A d d e n d u m

Iowa Department of Transportation
Office of Contracts

B.O.	Proposal ID	Proposal Work Type	County	Project Number	Addendum
111	79-0634-043	PCC PAVEMENT - GRADE & REPLACE	POWESHIEK	NHSN-063-4(43)--2R-79	17MAR111.A01

B.O.	Proposal ID	Proposal Work Type	County	Project Number	Addendum
111	79-0634-043	PCC PAVEMENT - GRADE & REPLACE	POWESHIEK	NHSN-063-4(43)--2R-79	17MAR111.A02

The estimate reference note for Item 22 on C.3 should read:

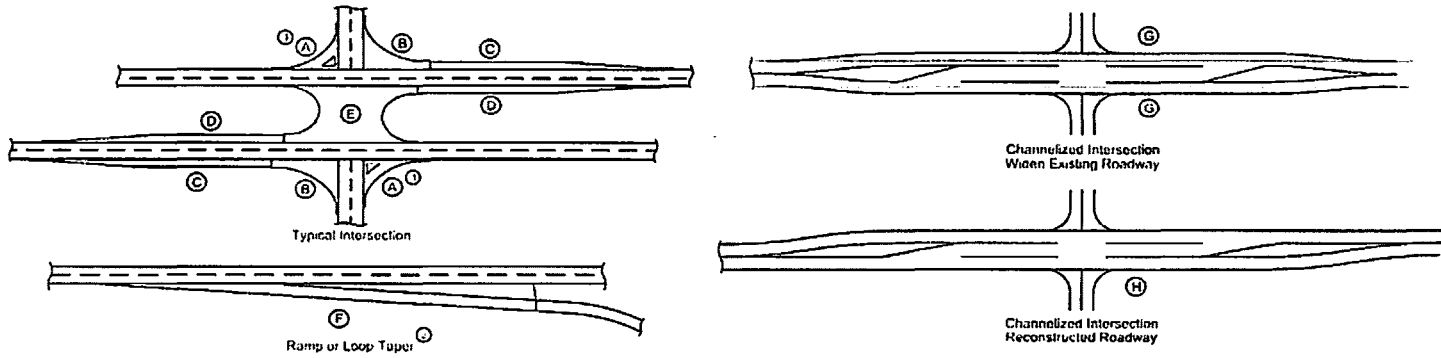
This item is for the removal of light poles. Refer to Sheet U.11 locations and details.

Transport all removed poles, luminaires, and associated hardware to the Malcolm Maintenance Garage. Notify the RCE three days prior to delivery to coordinate delivery with Maintenance staff. Delivery is required within normal hours of operation for Maintenance staff.

Equipment damaged by the Contractor's activities will be replaced at the Contractor's expense. Replacement materials will be new. The DOT will furnish all details necessary for fabrication of the replacement materials.

Measurement: The Engineer will count each light pole removed.

Payment: For each light pole removed, the Contractor shall be paid the contract unit price. This payment shall be full compensation for furnishing all material, equipment, and labor and for the performance of all work necessary to remove light poles from the project.
